# Technical Service Bulletin

SUBJECT:			No: <b>TSB-19-37-002</b>
<b>UPDATES TO TIE ROD END BALL JOINT DUST COVER REPLACEMENT - SMR</b>			DATE: <b>February 2019</b>
			MODEL: <b>See below</b>
<b>CIRCULATE TO:</b>	<input type="checkbox"/> GENERAL MANAGER	<input checked="" type="checkbox"/> PARTS MANAGER	<input checked="" type="checkbox"/> TECHNICIAN
<input checked="" type="checkbox"/> SERVICE ADVISOR	<input checked="" type="checkbox"/> SERVICE MANAGER	<input type="checkbox"/> WARRANTY PROCESSOR	<input type="checkbox"/> SALES MANAGER

This TSB updates the Steering section of the affected Service Manuals to update the lubricant, sealant, special tools, and procedures used in replacement of the Tie Rod End Ball Joint Dust Cover, which are now serviceable parts, for vehicles with electric power steering.

## TIE ROD END BALL JOINT DUST COVER REPLACEMENT

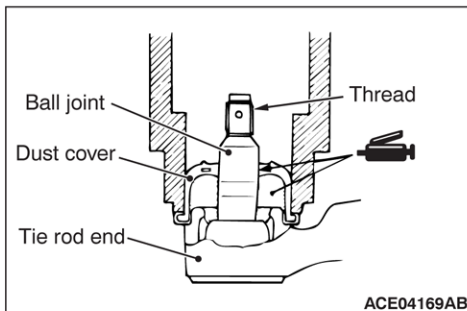
Please make the indicated changes below to the 2011 - 2015 Lancer and Lancer Sportback Service Manuals, Group 37-Steering -> 37B-Electric Power Steering (EPS) -> Power Steering Gear Box and Linkage, below "Disassembly and Reassembly":

<Added>

If the dust cover is damaged accidentally during service work, replace the dust cover as follows:

1. Fill and apply the specified grease into the inside and lip of the dust cover.

2. Apply the specified sealant to the dust cover mounting surface at the tie rod end.

3. Drive in the dust cover with special tool front axle base (MB990776) until it is fully seated.

- *There should be no grease on the thread of the ball joint.*
- *There should be no clearance between the dust cover and the tie rod end.*

4. Check the dust cover for cracks or damage by pushing it with your finger.

**Inside of dust cover:  $5.0 \pm 1.0$  g ( $0.18 \pm 0.04$  oz)**

**Semi-drying sealant: ThreeBond 1215 or equivalent**

## TIE ROD END BALL JOINT DUST COVER REPLACEMENT

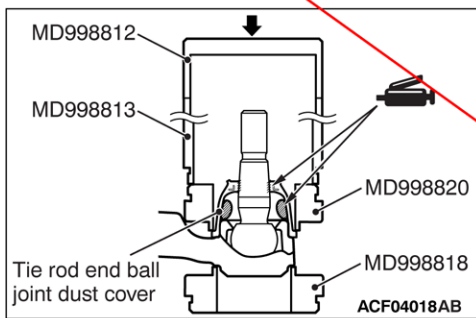
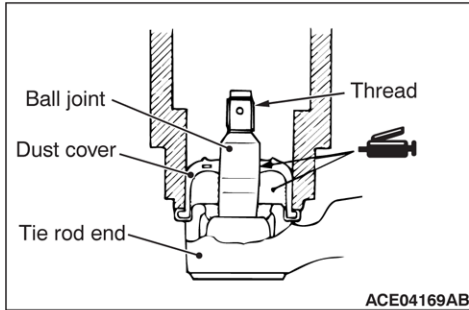
Please make the indicated changes below to the 2016 Lancer and Lancer Sportback Service Manuals, Group 37-Steering -> 37B-Electric Power Steering (EPS) -> Power Steering Gear Box and Linkage, below "Disassembly and Reassembly":

If the tie rod end ball joint dust cover is damaged accidentally during service work, replace the tie rod end ball joint dust cover as follows:

1. Fill and apply the specified grease into the inside and lip of the tie rod end ball joint dust cover.

2. Use the following special tools to press-fit the tie rod end ball joint dust cover into the tie rod end.

- Cap installer (MD998812)
- Installer 100 (MD998813)
- Installer adapter (MD998818)
- Installer adapter (MD998820)

<Incorrect>

<Correct>

1. Fill and apply the specified grease into the inside and lip of the dust cover.

**Inside of dust cover:  $5.0 \pm 1.0$  g ( $0.18 \pm 0.04$  oz)**

2. Apply the specified sealant to the dust cover mounting surface at the tie rod end.

**Semi-drying sealant: ThreeBond 1215 or equivalent**

3. Drive in the dust cover with special tool front axle base (MB990776) until it is fully seated.
